# SAN FRANCISCO PLANNING DEPARTMENT

## Discretionary Review Full Analysis

*Date:* June 9, 2016  
*Case No.:* 2015-003610DRP  
*Project Address:* 2181 9<sup>th</sup> Avenue  
*Permit Application:* 2015.03.19.1328  
*Zoning:* RH-1(D) (Residential House, One-Family-Detached)  
40-X Height and Bulk District  
*Block/Lot:* 2860/004  
*Project Sponsor:* Alexander Lirisman  
Forum Design  
1014 Howard Street  
San Francisco, CA 94103  
*Staff Contact:* Nancy Tran – (415) 575-9174  
[nancy.h.tran@sfgov.org](mailto:nancy.h.tran@sfgov.org)  
*Recommendation:* **Do not take DR and approve the project as proposed**

2181 Ninth Avenue  
**Alternate Concepts**

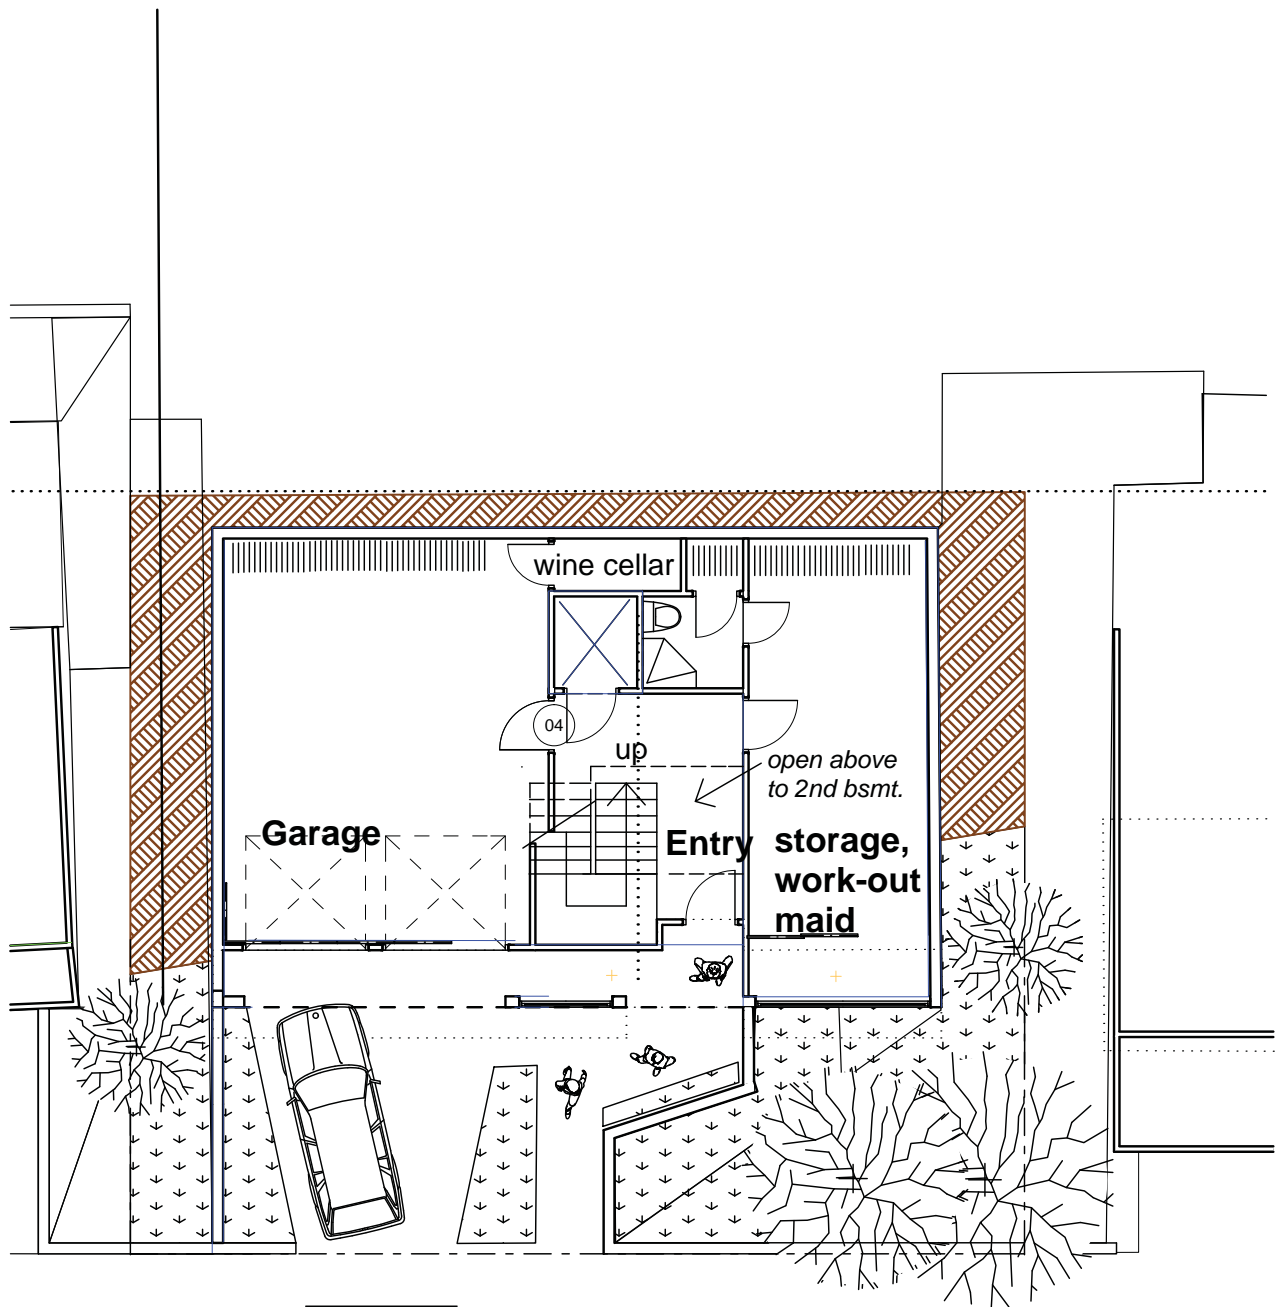
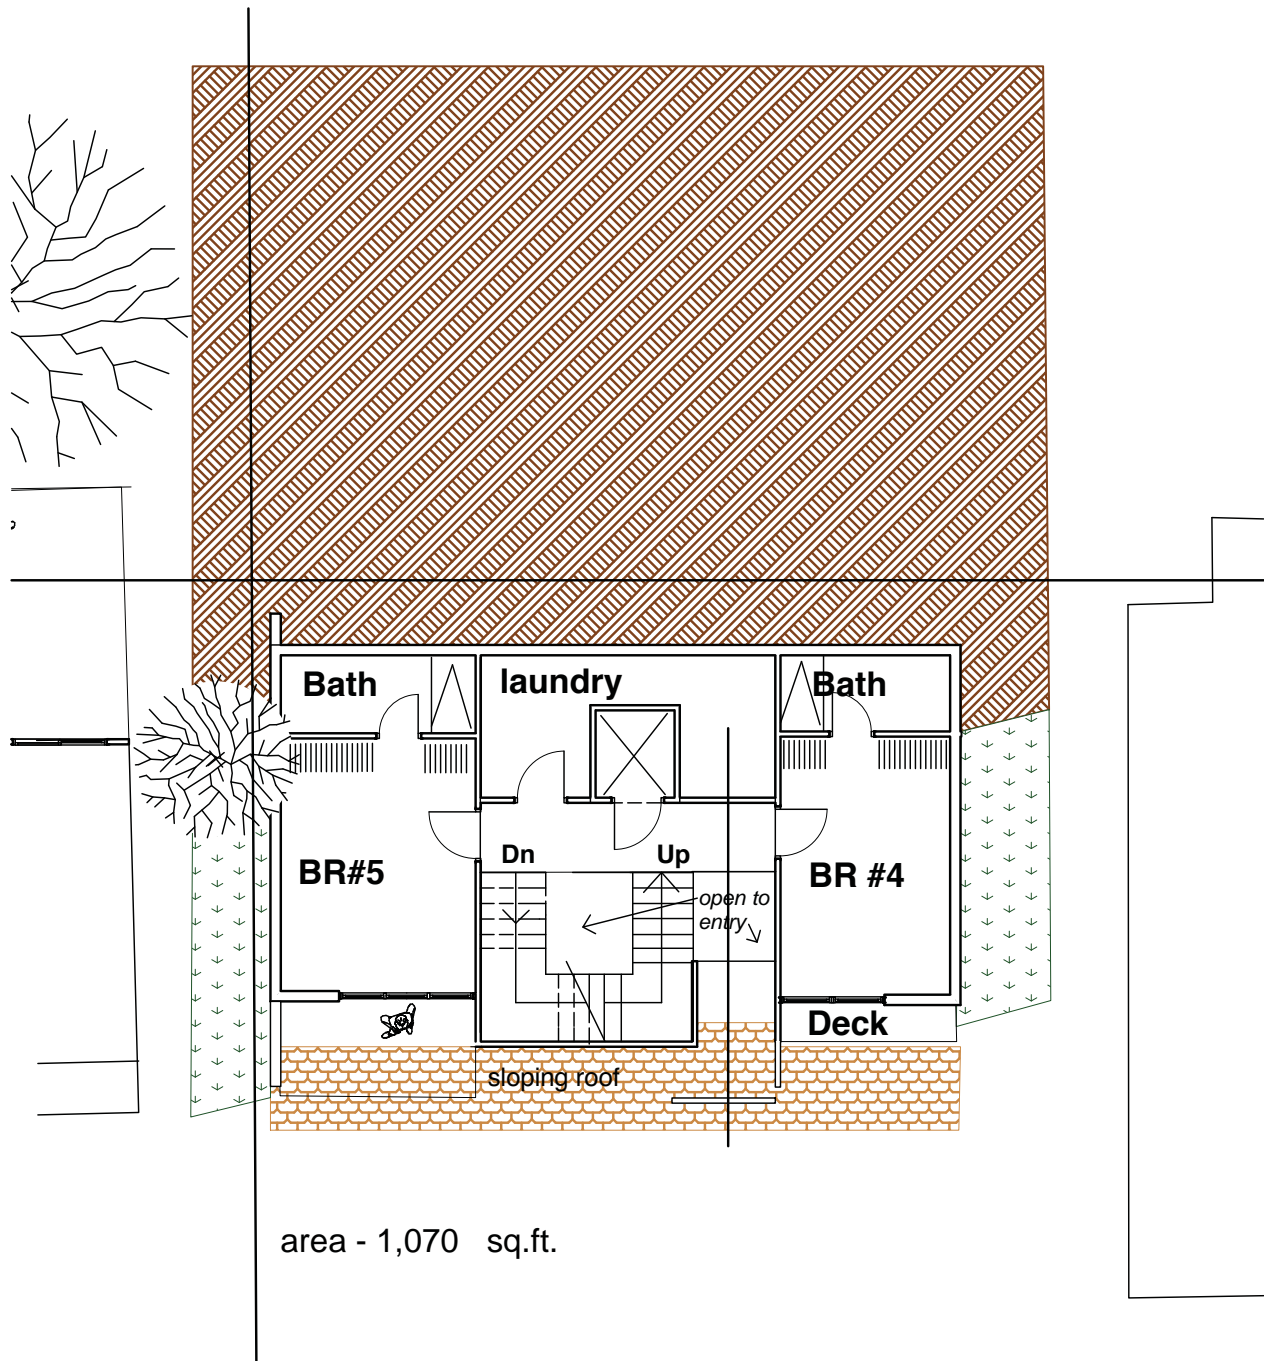
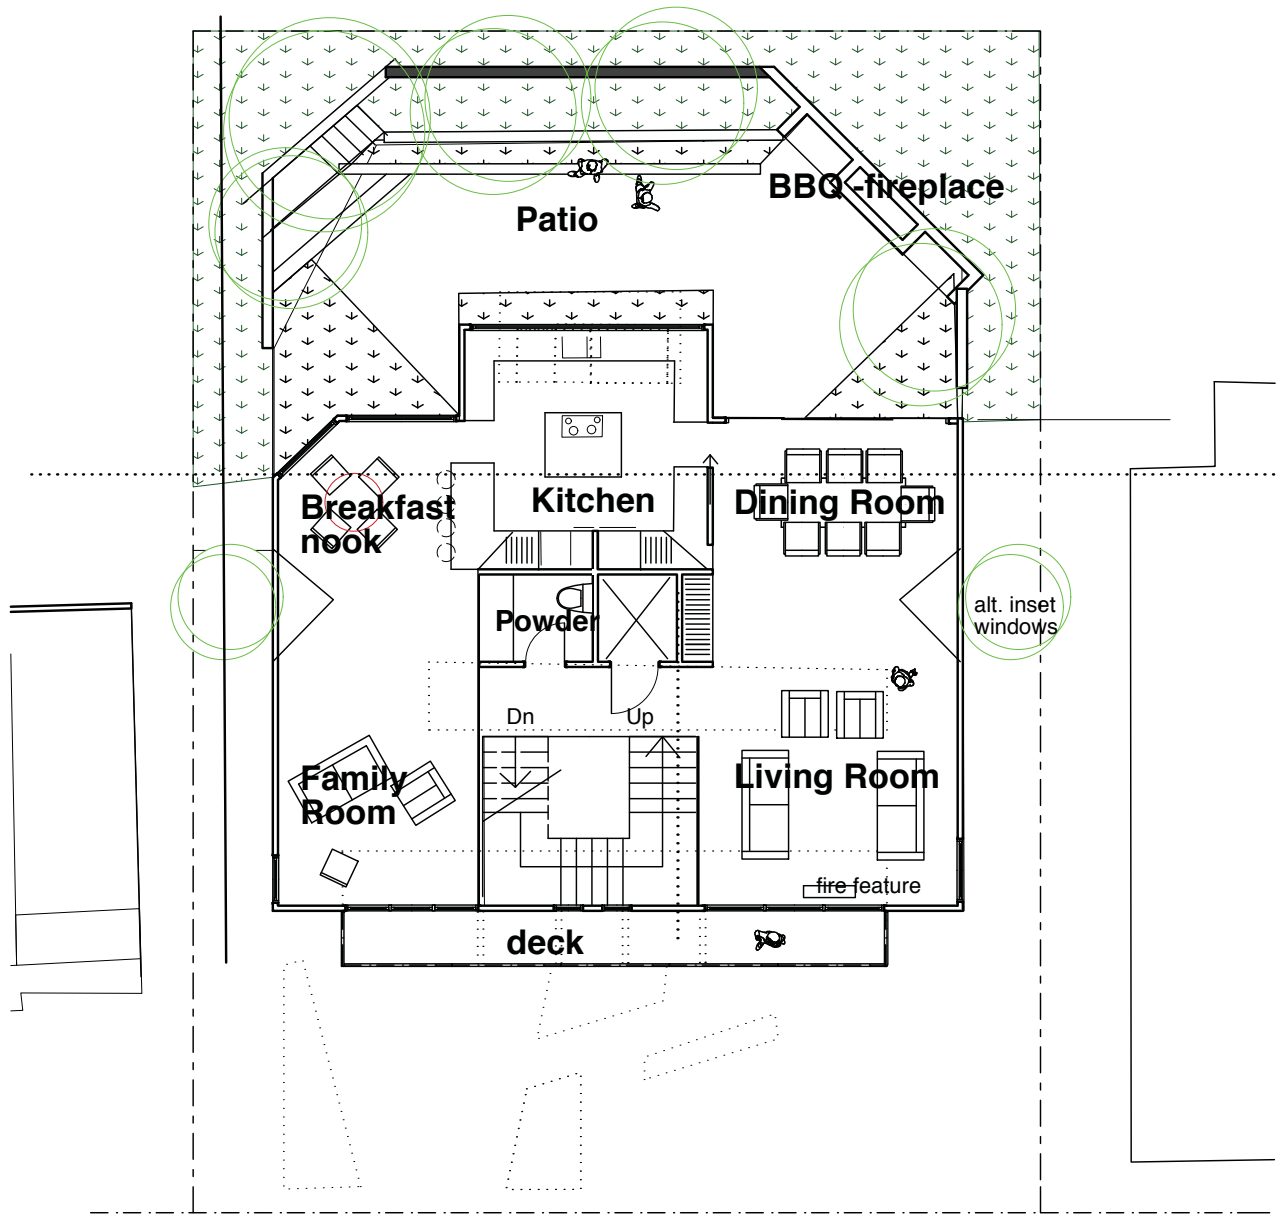
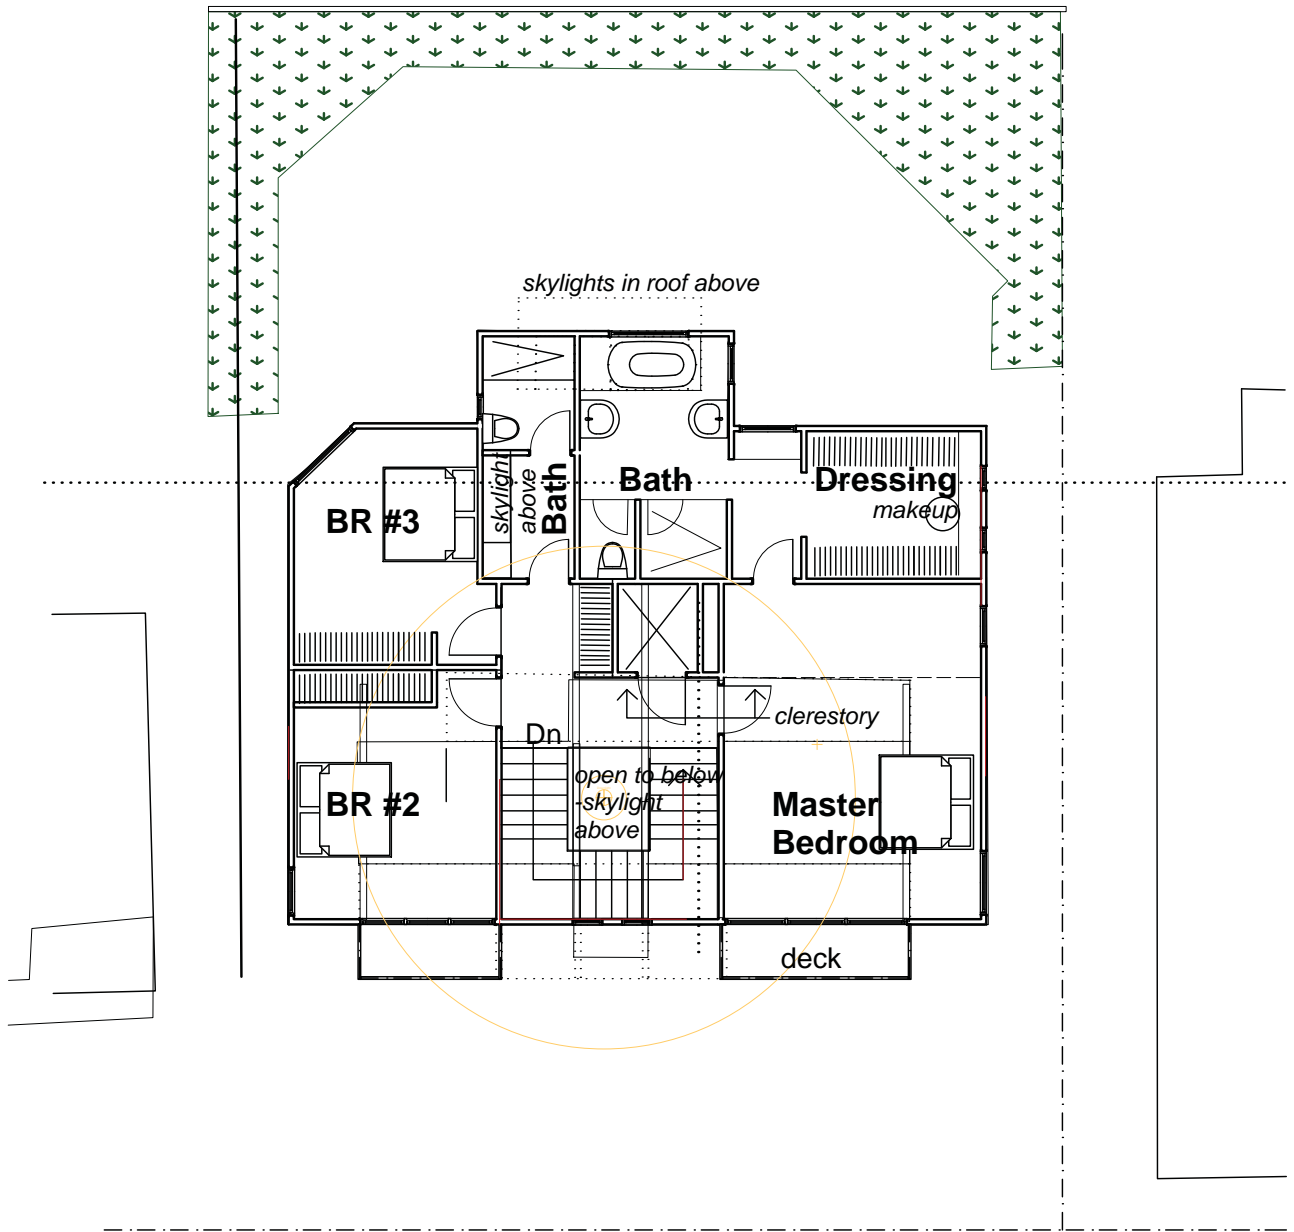
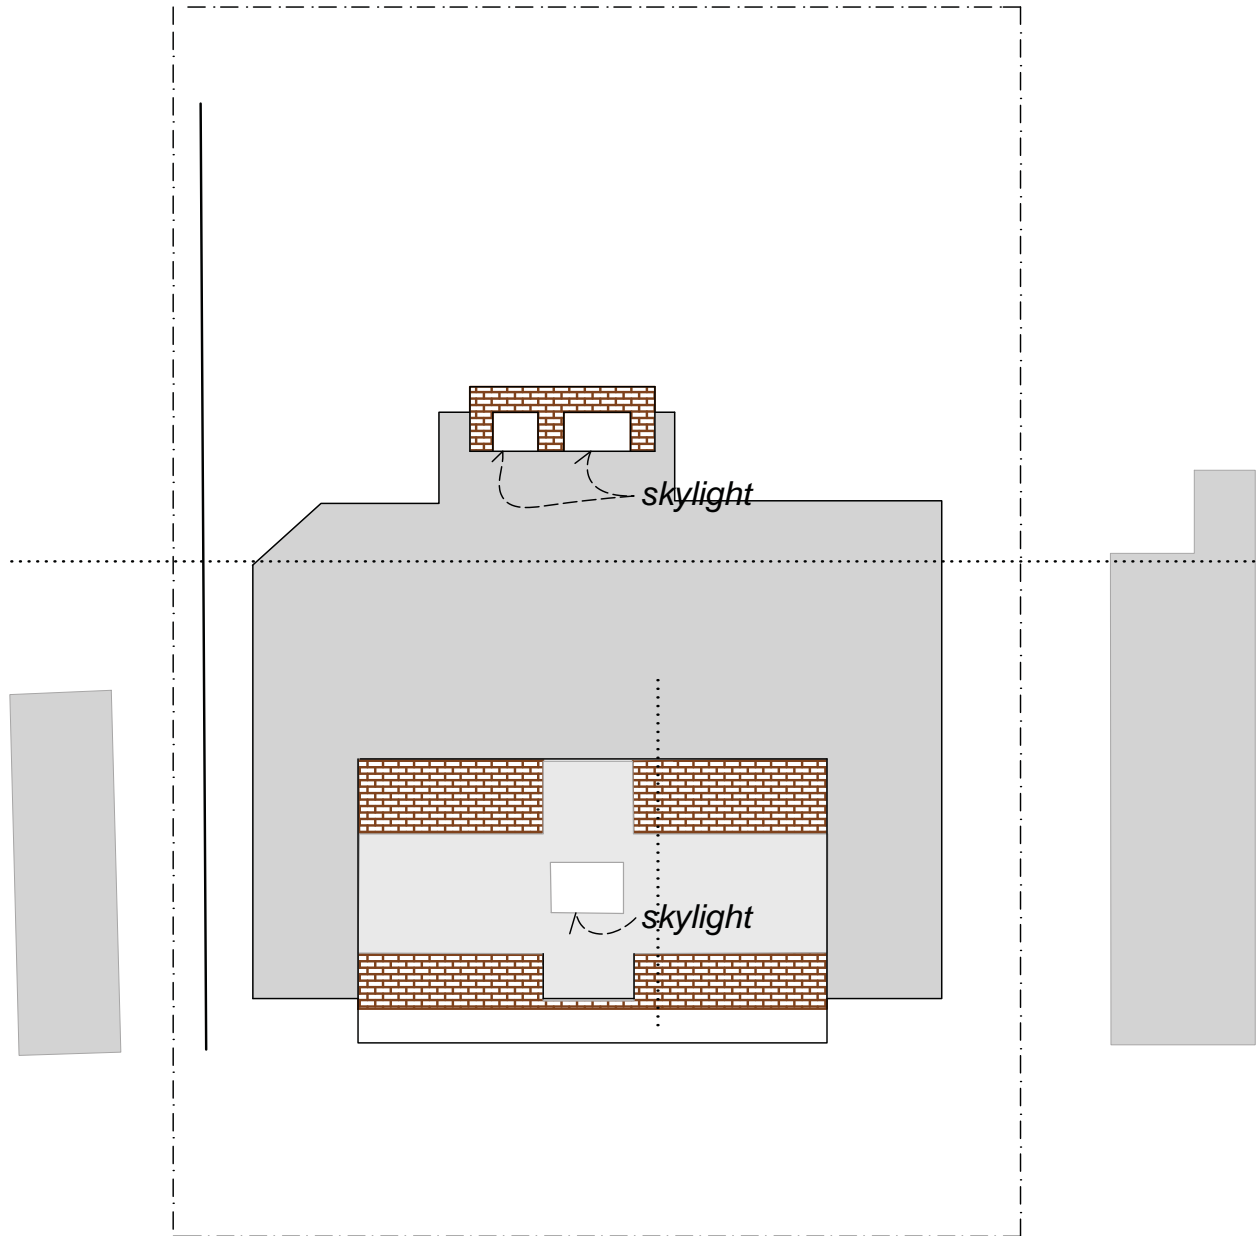
- Reduce the front setback to align the main front facade with neighboring houses, and move the rear facade of the house toward the street. This can be accomplished by moving floors 3 & 4 forward some 4'. see *alt. concept plans*

- Revise front facade to give it a less jarring contrast to the rest of the neighborhood. This includes eliminating the massive front bay that encloses the stairs and the similarly massive architraves around the garage door and front entry. This can be accomplished by (1) turning the stairs so they can be enclosed behind the front wall, (2) changing the material of the recessed second basement wall to accentuate this floor's setback, and (3) reducing the size and number of the front decks, and possibly adding some sloping roofs. Each of these can aid in lowering the visual height of the structure.
